# **WOLVERCOTE & WATERWAYS**

## **RAIL NOISE SURVEY & MITIGATION STATEMENT**

**March 2019**

SECTION I/1 NOISE BARRIER  
PLANNING DETAILS

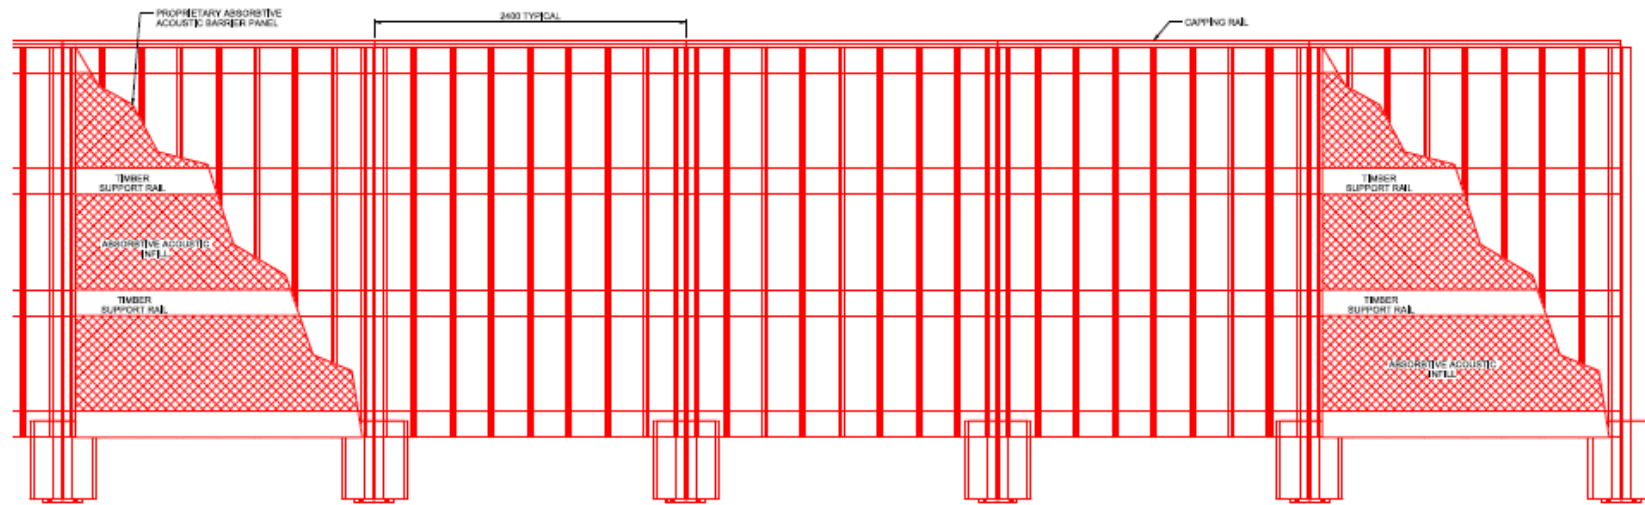
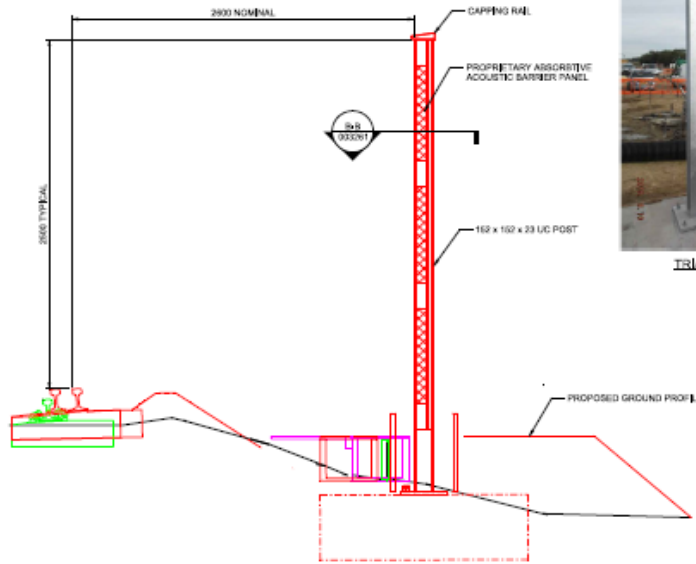
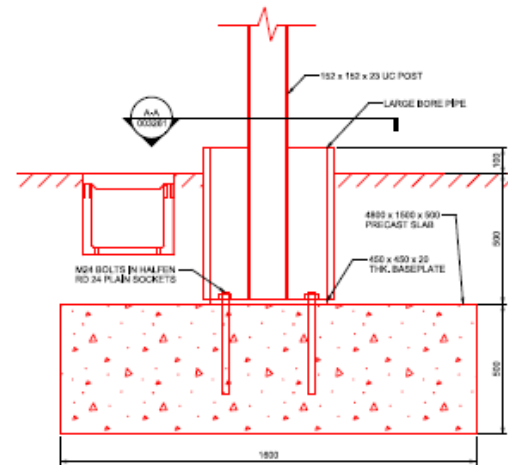
Appendix B provides the Section I/1 noise barrier planning details for the noise barrier system. This is shown to be based on a 2.5m high timber absorptive noise barrier design. The drawing itself provides specification details for the barrier itself which is dealt with below in 5.3. It is not entirely clear how authoritative the drawing is or whether it constitutes the specification for the tender for the barrier scheme.

The drawing in Appendix B refers to BSEN acoustic test standards to specify the performance of the barrier however the specification details are somewhat confusing:

- At the time of design (2016), an absorptive noise barrier for the UK rail network under direct sound field conditions would need to be tested and certified for the following standards:
  - 16272-6:2014 for in situ airborne sound insulation under direct sound field conditions
  - 16272-1:2012 for sound absorption under diffuse conditions.

*(at the time of design there was not an equivalent rail test standard published for sound absorption based on barriers under direct field conditions).*

- Item 7 in the drawing requires the following:
  - Noise insulation performance shall be tested in accordance with BSEN 16272-2. *(at the time of design this was not the correct rail test standard published for airborne sound insulation based on barriers under direct field conditions).*
  - All panels shall carry a CE Marking in accordance with the Construction Products Regulations (2013) ... to demonstrate conformity with this specification. *(to this date there is no hEN harmonised standard for the specification and CE Mark certification of rail noise barriers. There is one for road noise barrier: BSEN 14388:2005 (current harmonised version) which I co-authored but this is based on a different suite of test standards)*

In summary it is not clear what the performance specification of the installed 2.5m timber absorptive noise barrier system is nor its origin and whether the resulting barrier installed actually meets that specification. We would therefore recommend that a request is made to find out who the noise barrier contractor(s) are that both manufactured and installed the barrier and for the performance test certification of the barrier supplied and how it was assessed against the specification to determine whether it is actually fit-for-purpose. It would also be worth requesting a copy of the CE Mark and Declaration of Performance since that has been made a prime aspect of the specification.
